Application for Works Approval

Works Approval Number	W6711/2022/1
Applicant	EcoMag Dampier Pty Ltd
ACN	622 727 208
File number	DER2022/000212
Premises	Karratha Demonstration Magnesium Recovery Plant 1 Millars Road, Gap Ridge WA 6714 Part of Lot 267 on deposited plan 93179 City of Karratha As defined by the coordinates in Schedule 2 of the works approval
Date of report	28 November 2022
Decision	Works approval granted

Figure 3: The ponds the bitterns are pumped in from and out to. Bitterns are pumped in from concentration pond #4 and spent bitterns are pumped out to the spent bitterns evaporation pond. Water from reverse osmosis (RO) is pumped in from the desalination plant.

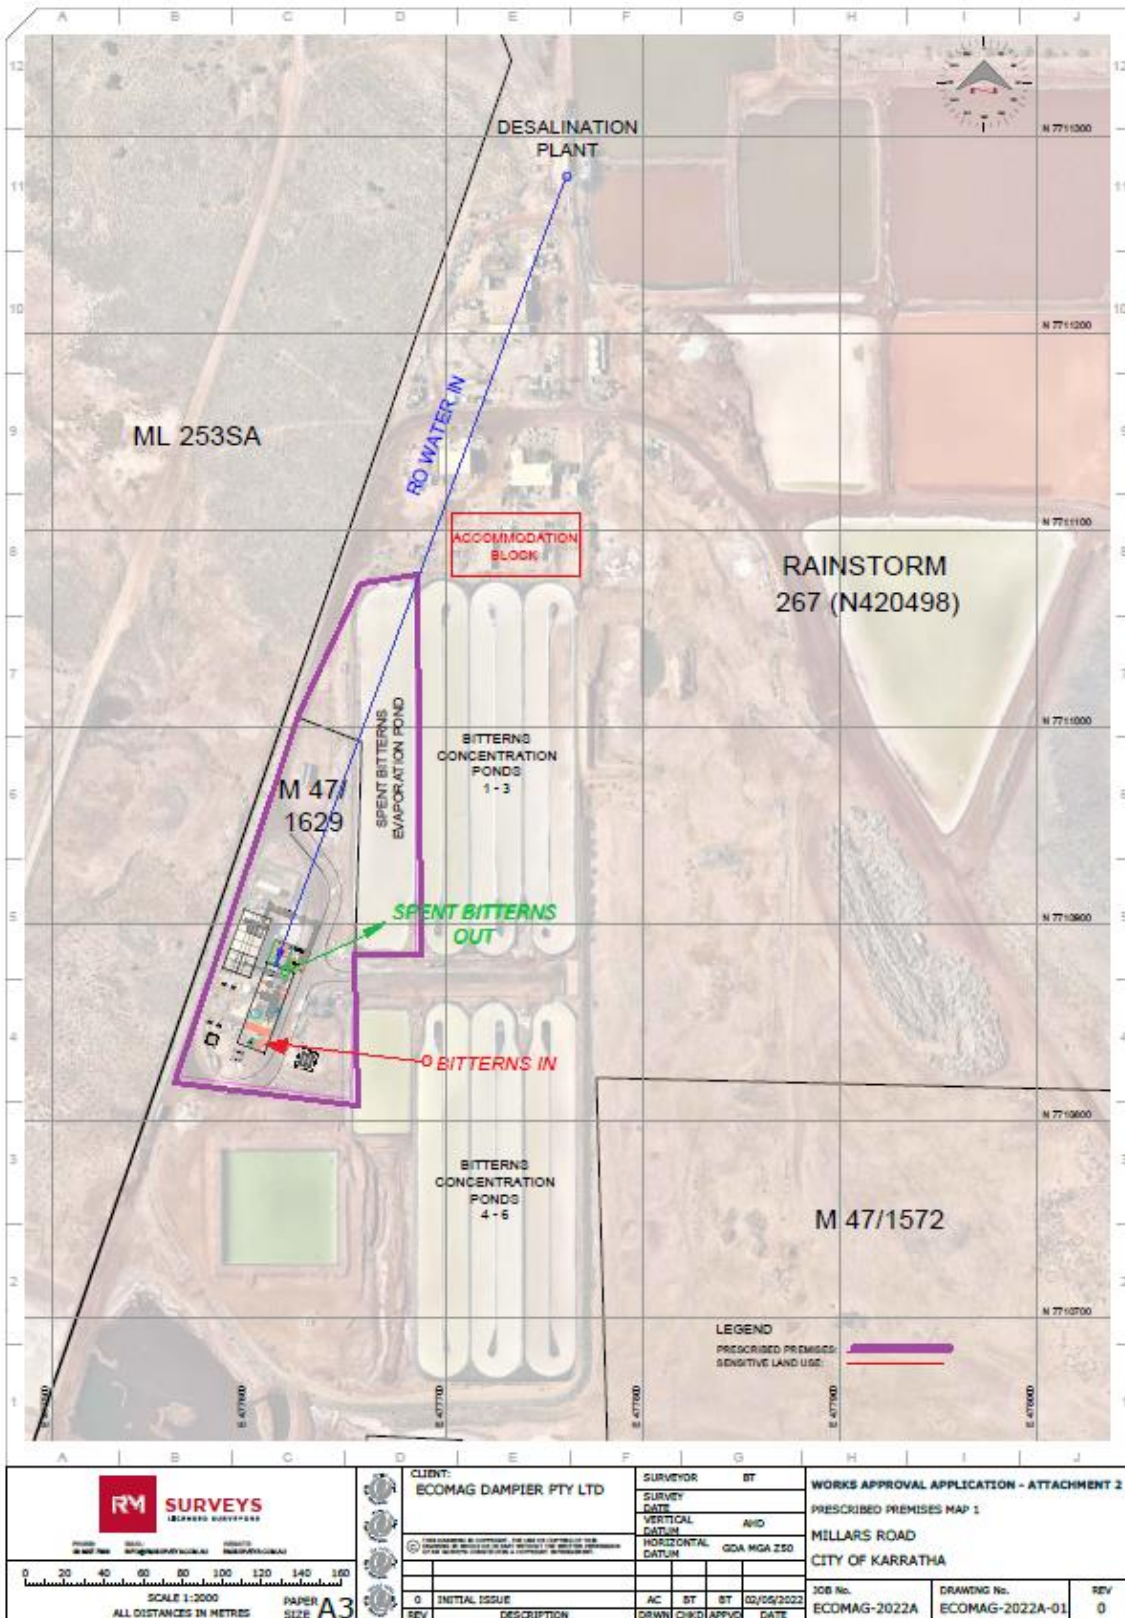
Condition	Summary of applicant's comment			Department's response
	Parameter	Target	Units	
	pH	<10.5		
	Conductivity	135	µS/cm	
Decision Report Page 1 – 2, 5	<p><i>Applicant please clarify the input and output ponds offsite using the terms 'Bitterns Concentrator Pond' (and which number) and whether the 'Spent Bitterns Evaporation Pond' as per Figure 2 below, is used at all. The application sounds like only "off-site" ponds are used and the "on-site" pond is not. A figure showing the pumps connecting the ponds and the demonstration plant would also be useful.</i></p> <p>The plant feed bitterns (BITTERNS IN) are pumped from Bitterns Concentration Pond # 4 (off-site) to the processing plant. Waste liquor from the processing plant is pumped to the Spent Bitterns Evaporation Pond (on-site). Refer to Figure A for solution flow outline.</p>			Text updated with clarifications. Inclusion of Figure 3.
Note 1 Table 1, Page 15	<p><i>Ecomag to provide details of flue gas species composition / concentrations and provide a map showing point source emission to air locations (stacks).</i></p> <p>The flue gas compositions are displayed in Table A.</p> <p>A map showing the approximate locations of the stacks and emissions directions during predominant wind directions are displayed in Figure B.</p>			Text updated to include flue composition and figure 10 (pg 18).
